ADDENDUM No. 2

RFP No. 24-23

Barton/Bandemer Park Pedestrian Tunnel Project

CITY OF ANN ARBOR PRS & WASHTENAW COUNTY PRC
BARTON/BANDEMER PARK PEDESTRIAN TUNNEL PROJECT
BOX CULVERT DETAILS

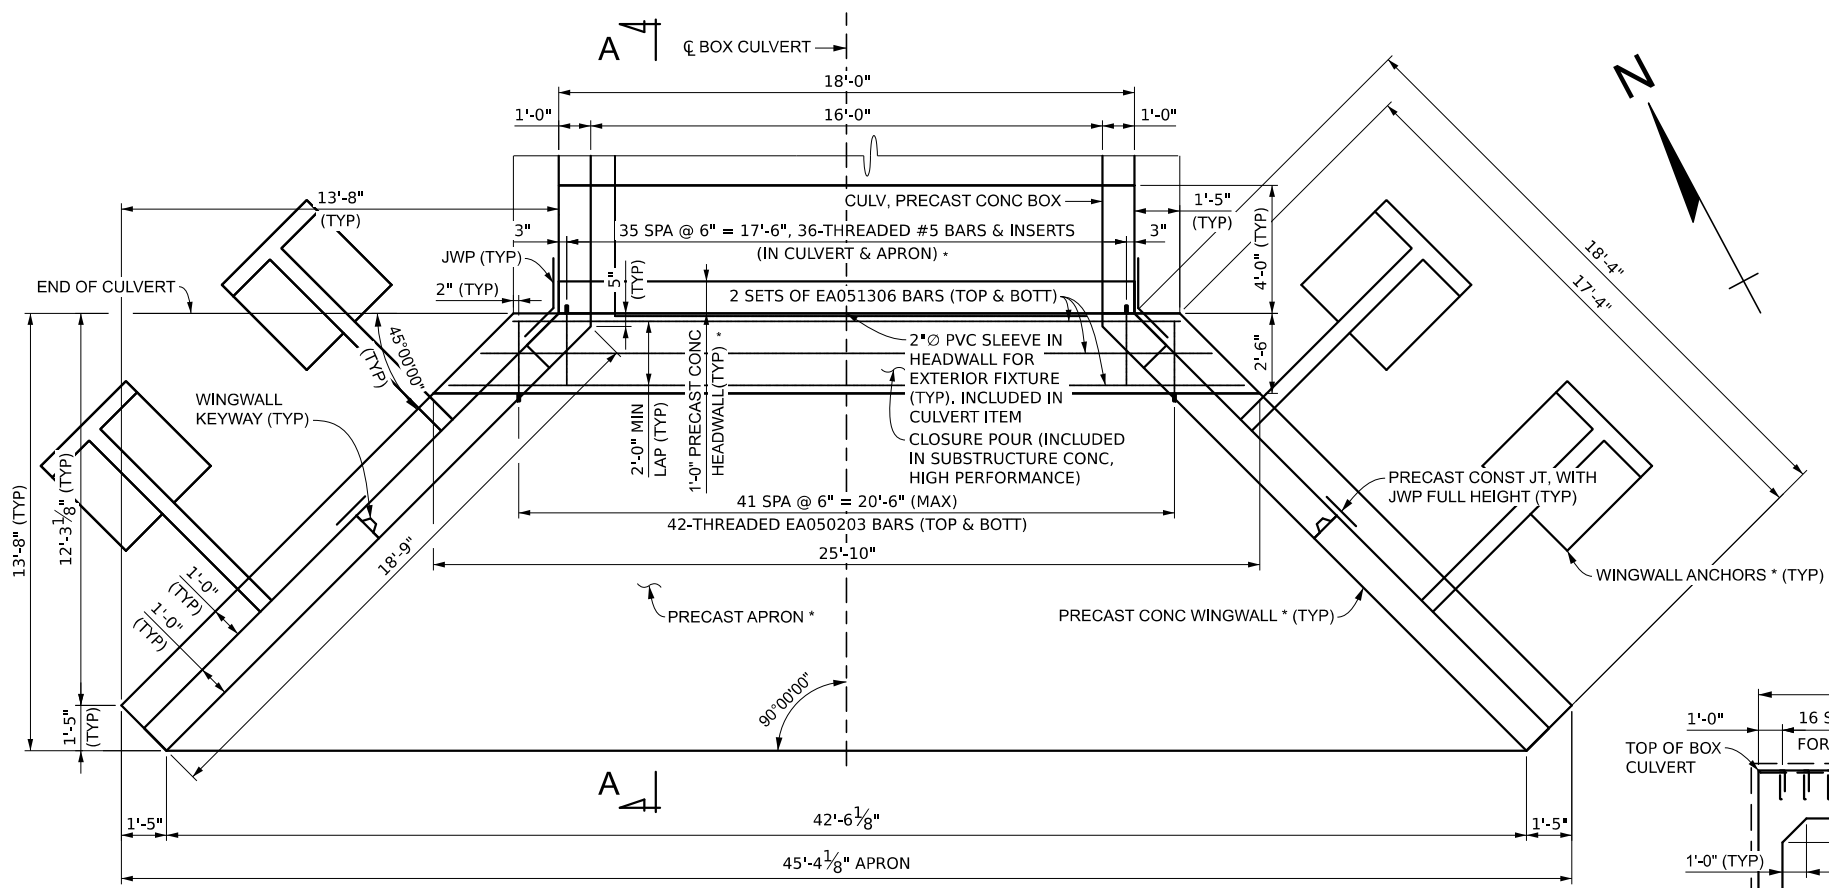
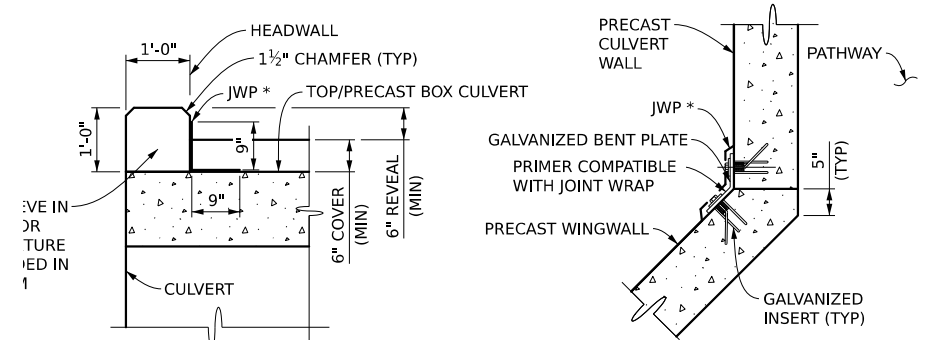
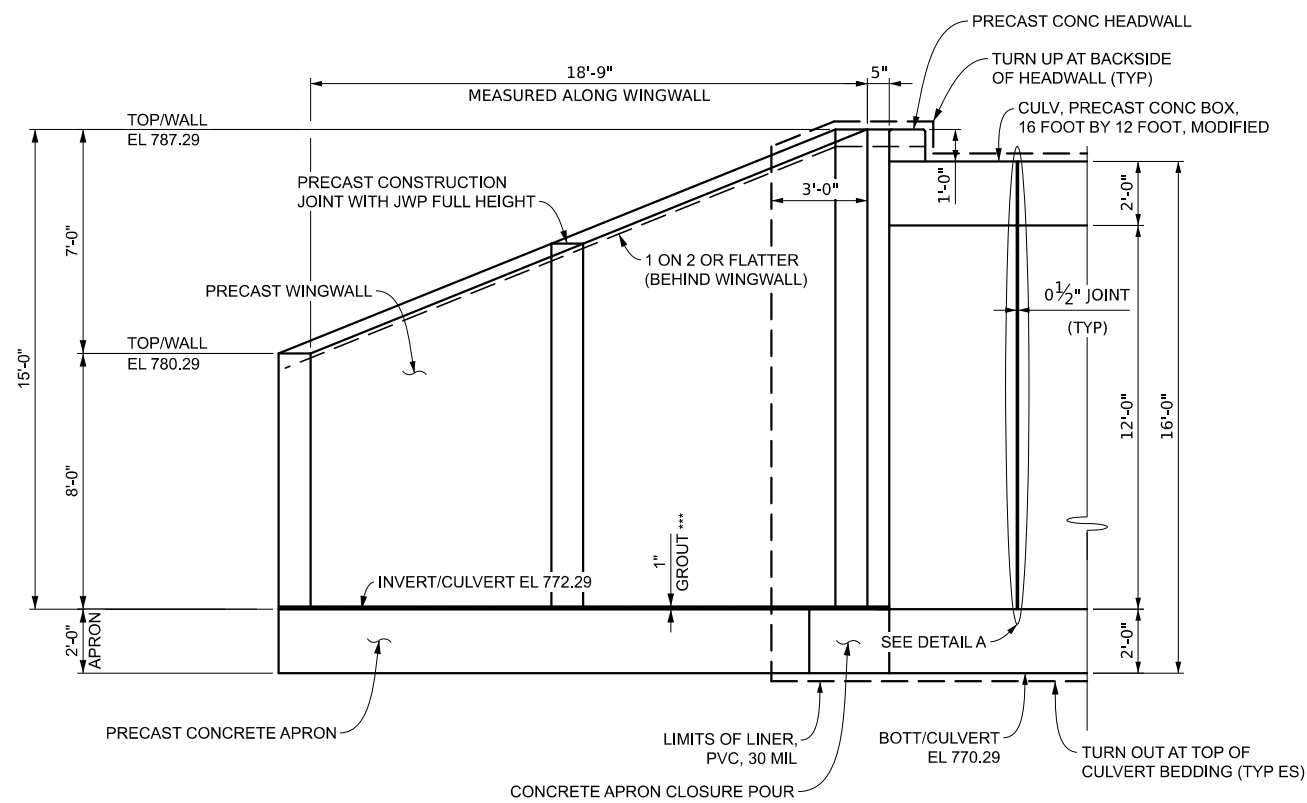
Section IV Detailed Specs	Updated Progress Clause to include approval by Amtrak for outage start and stop times. Updated Culvert, Precast Concrete Box, Modified definition of pay limits. Added requirement for a mock-up of the stone work in the Stone Masonry Façade specification and noted this mock up is not paid for separately.
Plans Page 14 of 80	Replace plan sheet. Updated profile.
Plans Page 16 of 80	Replace plan sheet. Updated profile near the timber bridge.
Plans Page 18 of 80	Replace plan sheet. Updated profile.
Plans Page 31 of 80	Replace plan sheet. Added waler and tie rod details.
Plans Page 34 of 80	Replace plan sheet. Added waler and tie rod details.
Plans Page 45 of 80	Replace plan sheet. Updated profile near the timber bridge.
Plans Page 47 of 80	Replace plan sheet. Added call outs for a sleeve to be placed in the headwall for the electrical conduit to go through to the exterior fixtures. Removed ** designation from the PVC Liner call out to clarify it is paid for separately and not included in the box culvert pay item.

The Liner, PVC, 30 mil item should be bid and will be paid for separately. The box details have not removed the ** designation from this item which should clarify this now.

SOUTH ELEVATION
(LOOKING NORTH)

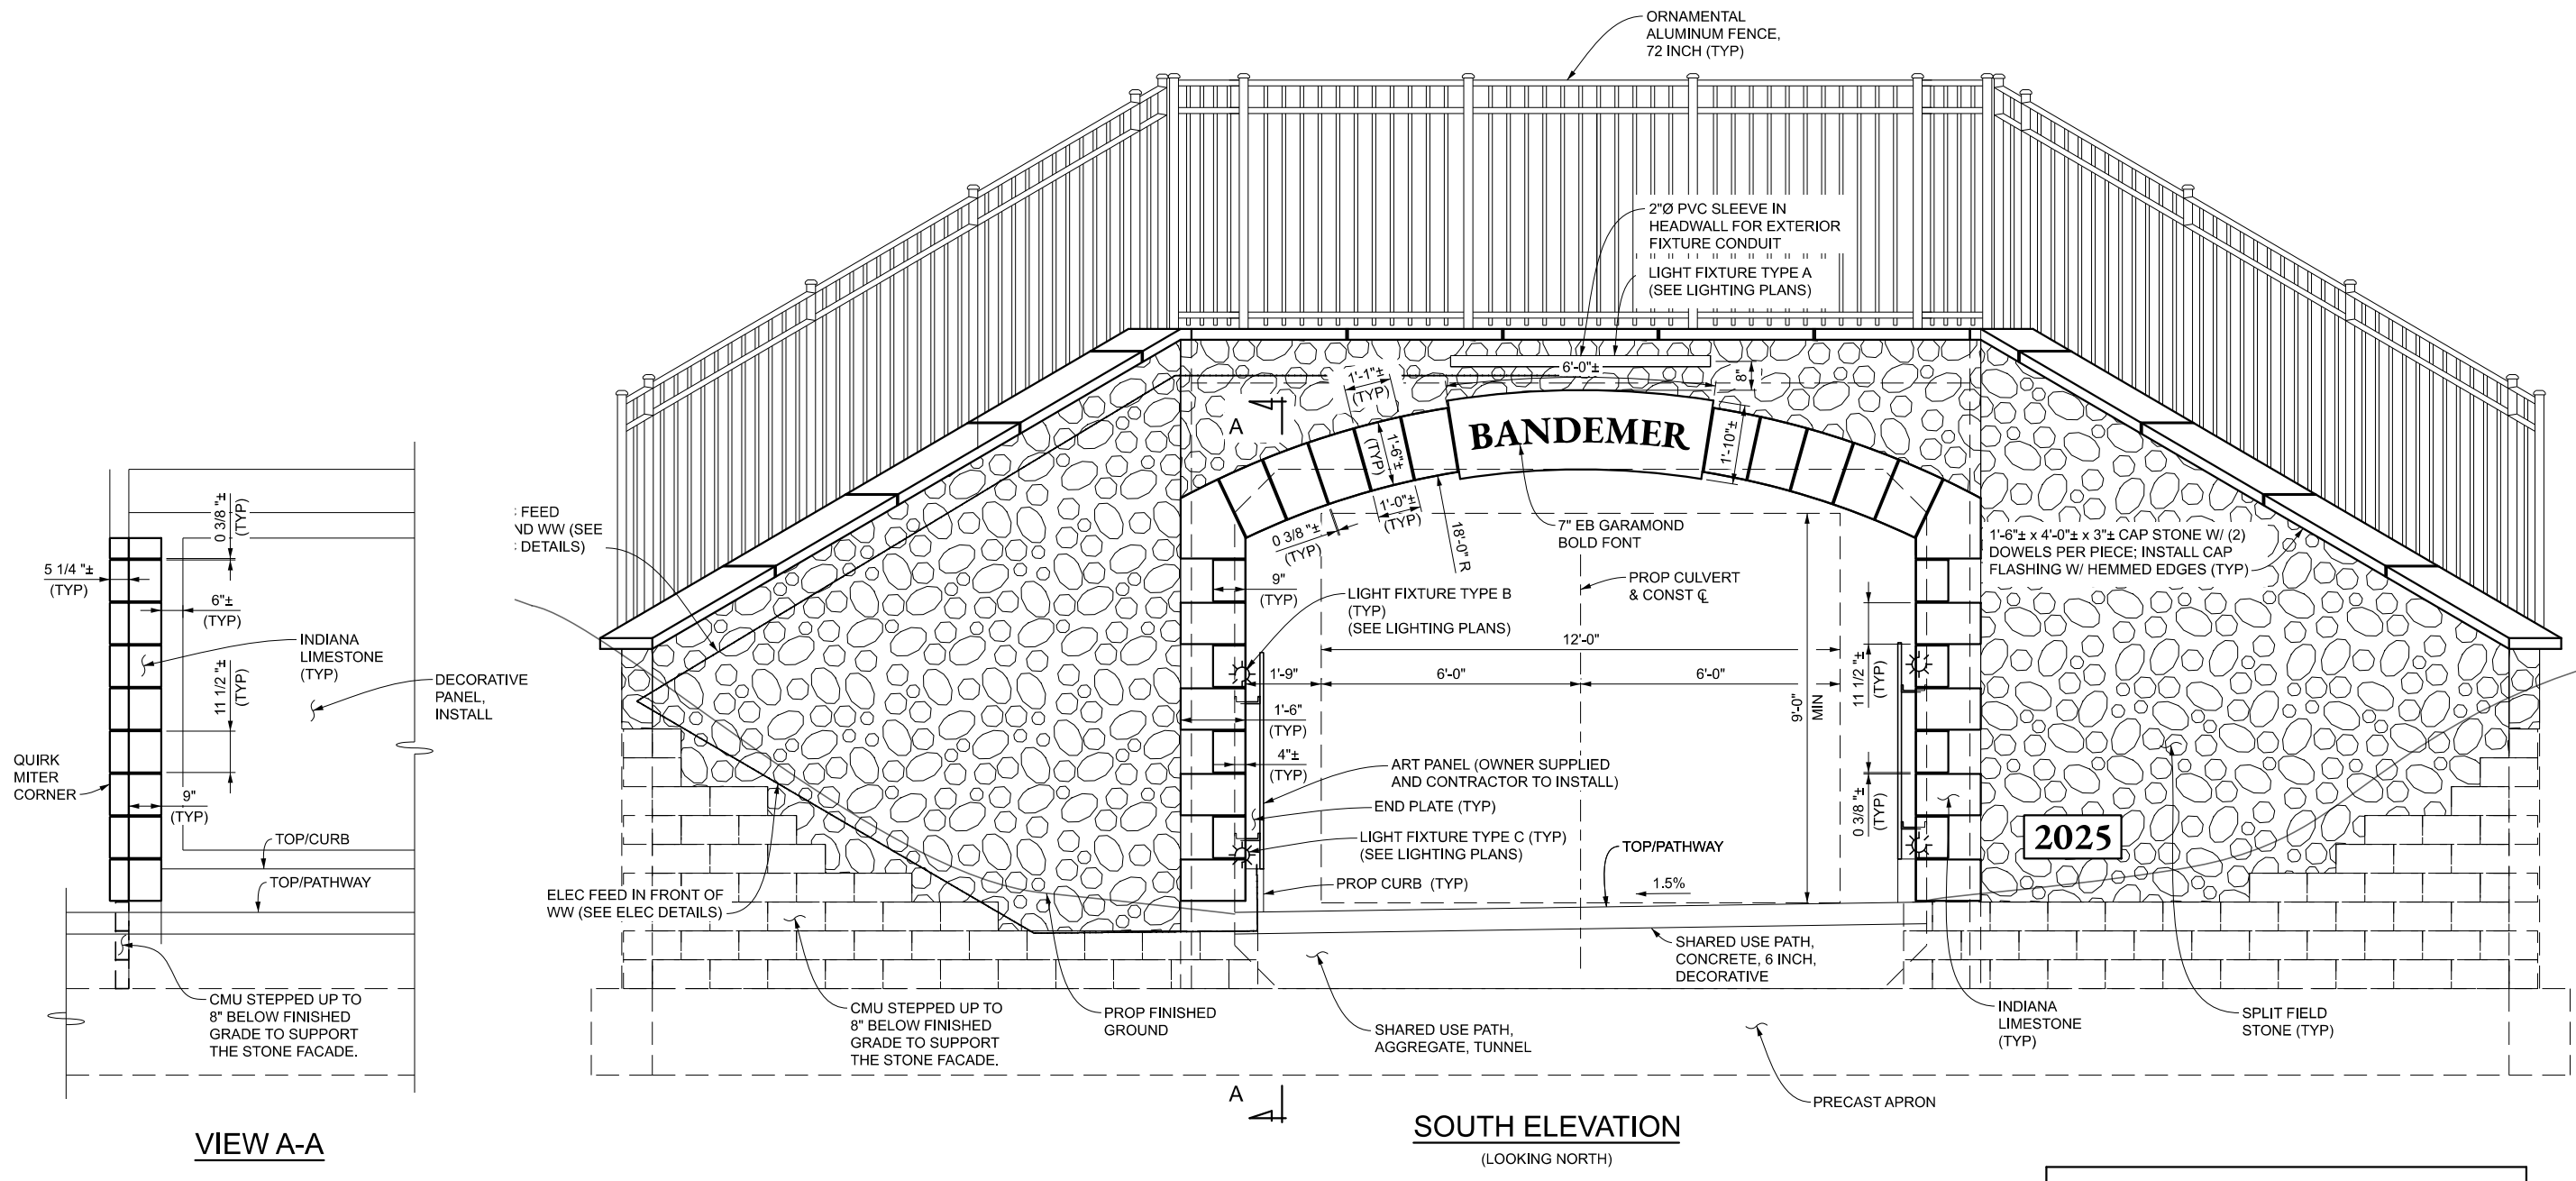
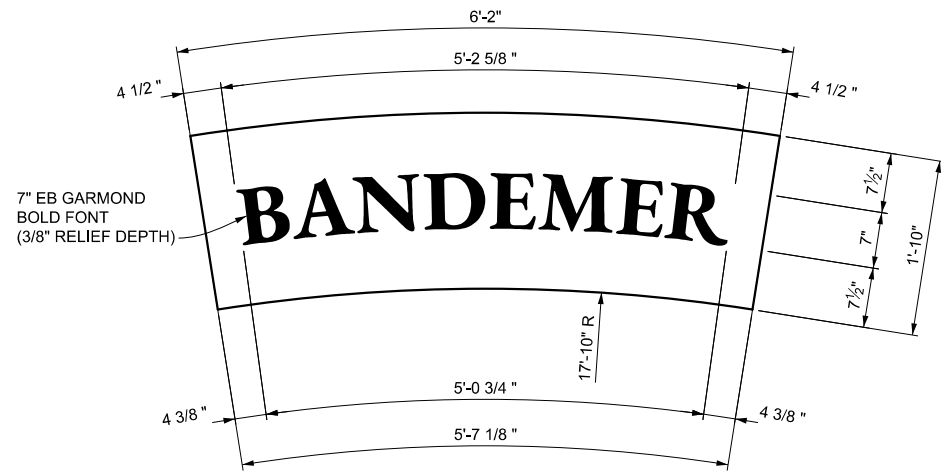
Plans Page 49 of 80	Replace plan sheet. Added call outs for a sleeve to be placed in the headwall for the electrical conduit to go through to the exterior fixtures. Showed conceptually the conduit running to the exterior fixtures. Changed the signage to be 2025 instead of 2024.
Plans Page 50 of 80	Replace plan sheet. Added call outs for a sleeve to be placed in the headwall for the electrical conduit to go through to the exterior fixtures. Showed conceptually the conduit running to the exterior fixtures. Changed the signage to be 2025 instead of 2024.
Plans Page 53 of 80	Replace plan sheet. Updated timber ped bridge details.
Plans Page 54 of 80	Replace plan sheet. Updated timber ped bridge details.
Plans Page 55 of 80	Replace plan sheet. Updated plan quantities. Updated plan view to indicate wiring and conduit in and around the culvert as well as two additional handholes.

1 ELECTRICAL SITEPLAN
SCALE: 1" = 30'-0"

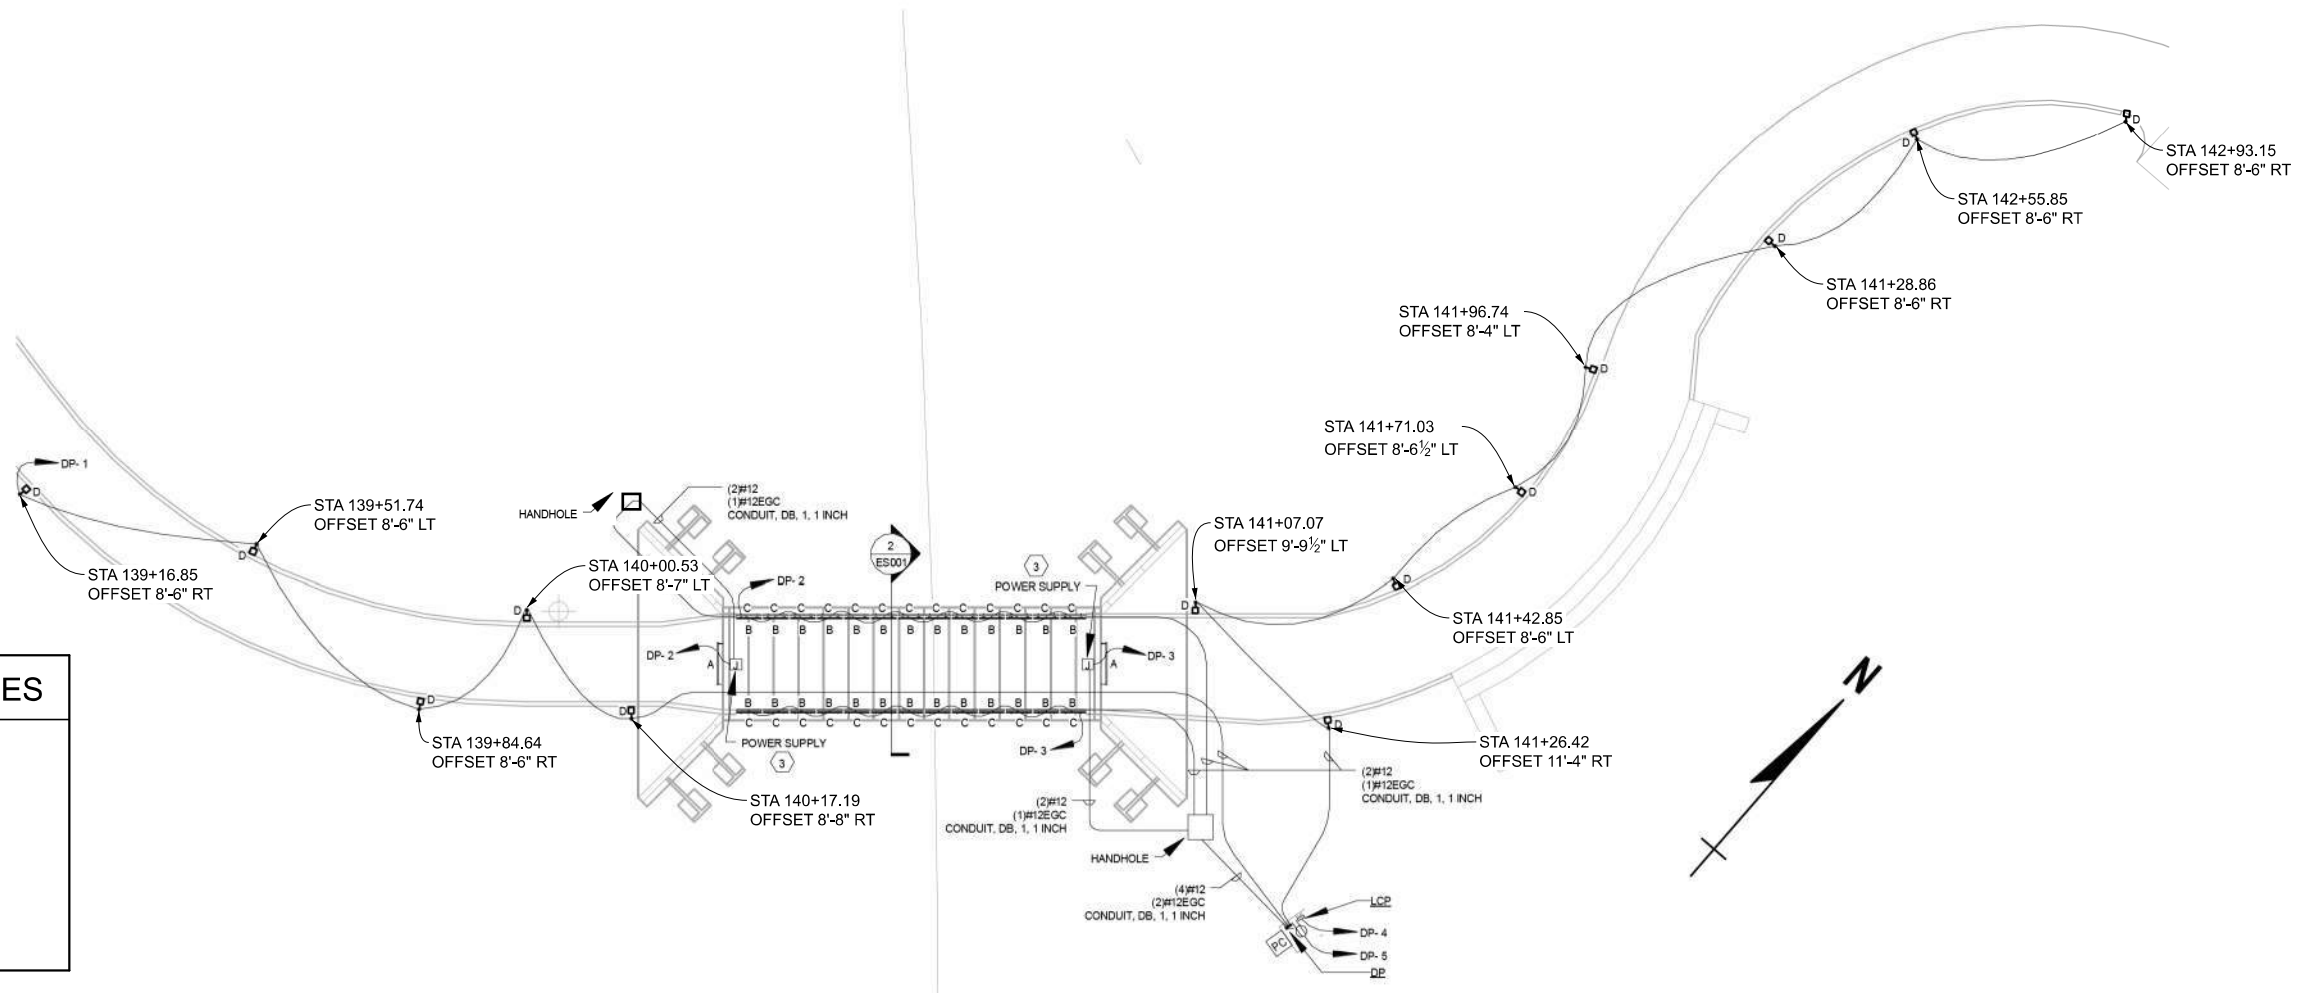
Pay items were updated to clarify conduit on the project. We also included call outs on the electrical sheets to clarify.
